L-TCI-5015

8AR Rocking (Forward and Back) Sensation on Acceleration

REVISION NOTICE

November 27, 2018, Rev. 1:

Figure 2. New No. 1 Vacuum Transmitting Hose Routing

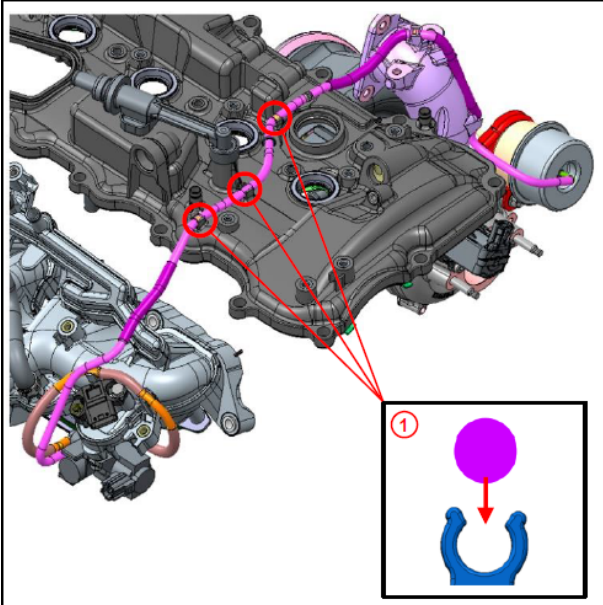
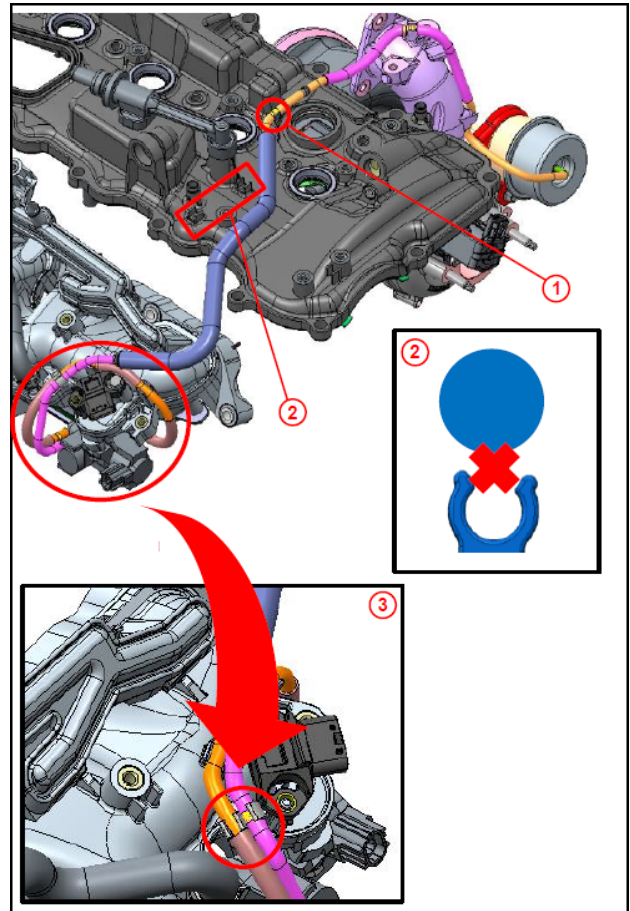
- Replace the No. 1 vacuum transmitting hose with the NEW No. 1 vacuum transmitting hose. Follow the routing as shown in Figure 2.

Figure 1 shows the routing of the previous No. 1 vacuum transmitting hose.

| 1 | No. 1 Vacuum Transmitting Hose Clamped to Cylinder Head Cover at One Portion |
| 2 | Cylinder Head Covers Incompatible With New No. 1 Vacuum Transmitting Hose |
| 3 | Additional Clamp Point (No. 1 Vacuum Transmitting Hose is Clamped to Other Hose by Using Hose Clamp) |
